Interactive comment on “Implementation of Polarization Diversity Pulse Pair Technique using airborne W-band radar” by Mengistu Wolde et al.

Mengistu Wolde et al.

Received and published: 19 November 2018

Fig. 1. 12 Z soundings the horizontal wind speed and direction obtained from two nearby radiosonde stations

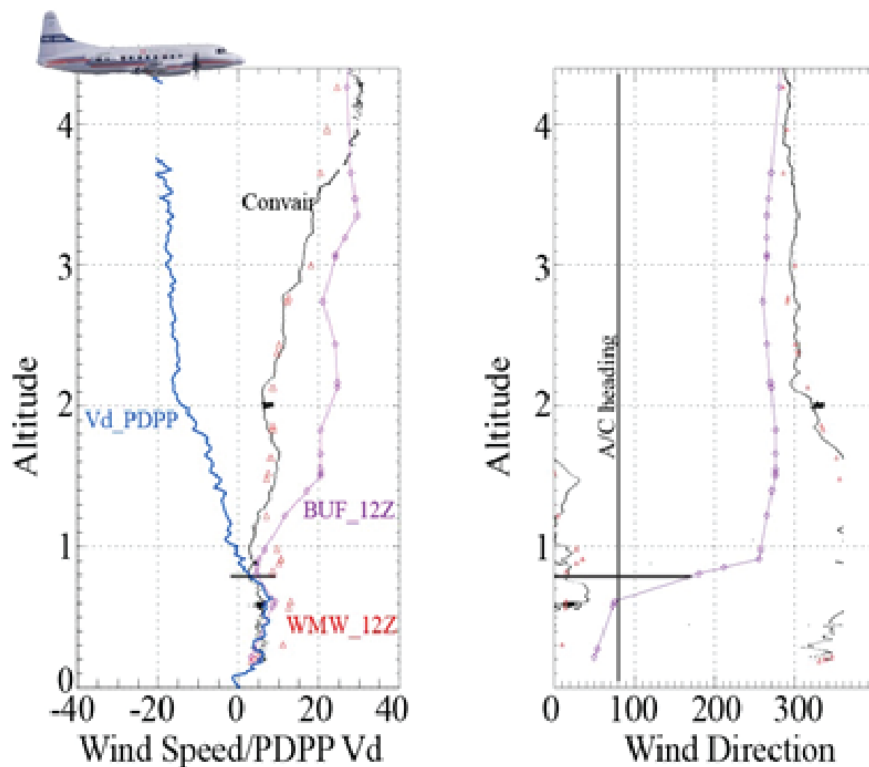
1. *EarthCARE CPR is designed for cloud vertical velocity measurements while WIVERN is target for horizontal wind retrieval. Have the author done or planned to do any horizontal wind retrieval based on airborne data?*

The objective of the project was to demonstrate the PDPP technique from a moving platform so our flight profiles were not optimized to do comparison of PDPP derived horizontal winds with vertical profile of horizontal winds. Even for the WIVERN satellite the scope is to measure horizontal winds along the line of sight and the information

However, we did a limited qualitative comparison of the PDPP Doppler velocity with a horizontal wind component obtained from radiosonde at proximity of the flight and the in-situ wind data measured by the aircraft wind system. In Fig. 1 (see attached), we plotted the 12 Z soundings (approximately 2 hours before the PDPP data collection) of the horizontal wind speed and direction obtained from two nearby radiosonde stations. In spite of the time and location differences of the soundings, both the radiosonde and aircraft sounding show a similar horizontal wind profile as the region was influenced by large scale synoptic system. The winds between 2 and 5 km were WNW with speed decreasing with altitude from 25 m/s at the aircraft altitude to nearly 5 m/s at 2 km altitude. Below 2 km, the wind veers with decreasing altitude and becoming light (< 10 m/s) north easterly. In this lower layer, the contributions of the terminal velocity from rain drops cannot be neglected so the Doppler velocity is a combination wind and particle fall velocity. These wind profiles are consistent with the PDPP observations showing a gradual decrease in magnitude from -20 m/s near flight level due to strong westerly winds (aircraft flying towards east) then reverse direction to weak vD of 0-10 m/s in a layer where with winds were north easterly (opposite to aircraft heading).

Figure 1(full caption): Left: vertical profiles of horizontal wind speed obtained during the Convair descent towards Ottawa after the PDPP data collection (black), 12Z upper air sounding from Buffalo (US) and Maniwaki (Canada) and profile of PDPP VD after aircraft motion correction (blue). Right: wind direction corresponding to the aircraft and BUF and WMW soundings. The vertical line correspond to the aircraft heading and the horizontal like is perpendicular to aircraft heading to the WVM sounding.

Figures 2, 3 and 4: PDPP Z_{hh} , Z_{hv} and retrieval Doppler for the March 29th, 2016 case.

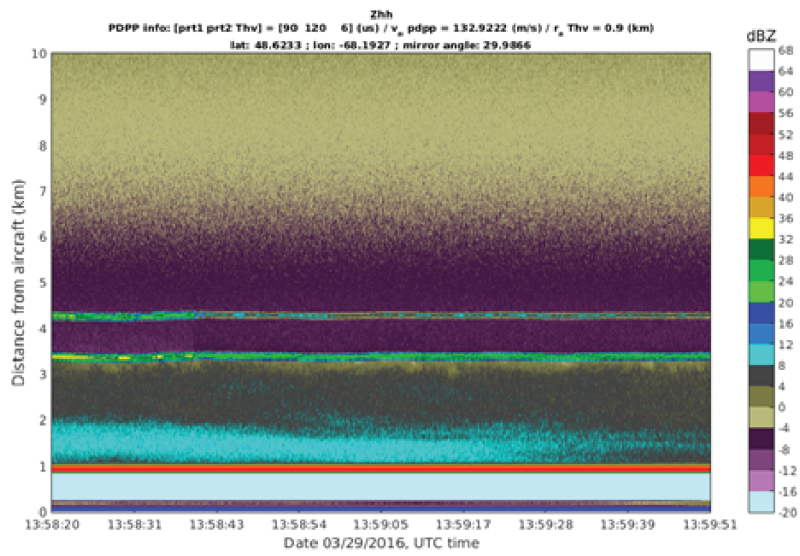
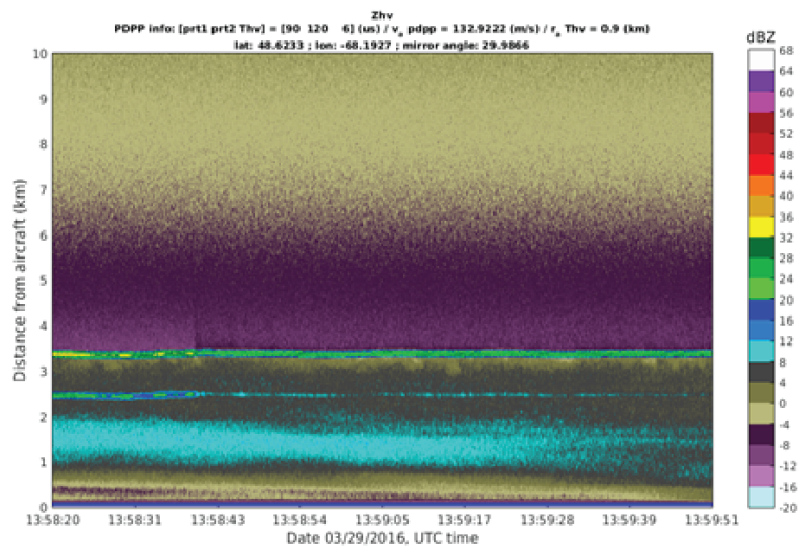
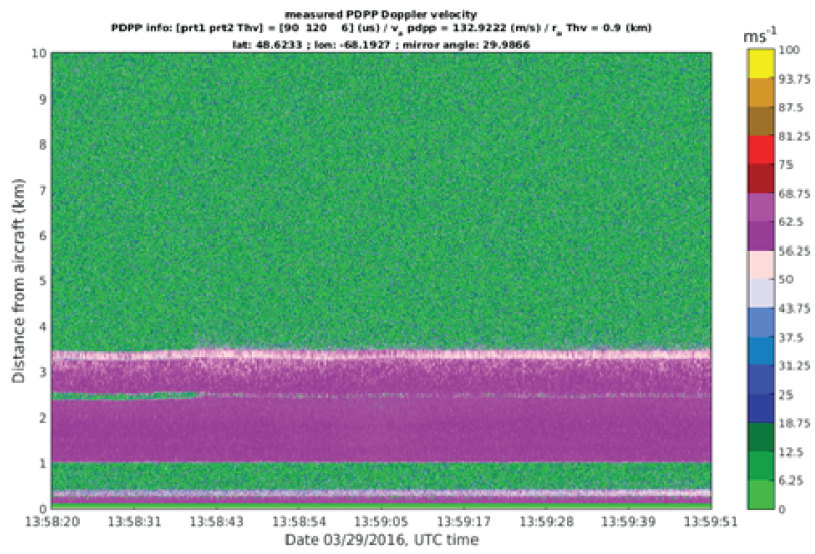
3. *What is the cross-pol isolation of NAWX channels? The SNR in the data case shown in Figure 9 seems high so the surface contamination from cross-pol seems not very significant. Is there any data case with weaker cloud/precipitation layer(s)?*

The cross-polarization isolation of the W-band channels mainly limited by the cross-pol of the antennas which is 30 dB for E-plane and 36 dB for H-plane. We have collected a few data sets where the SNR of cloud layers was low and cross-pol signals were much more significant (see Figs. 2-4). In those cases, Doppler velocities showed large errors or were not available in regions contaminated by cross-pol signals.
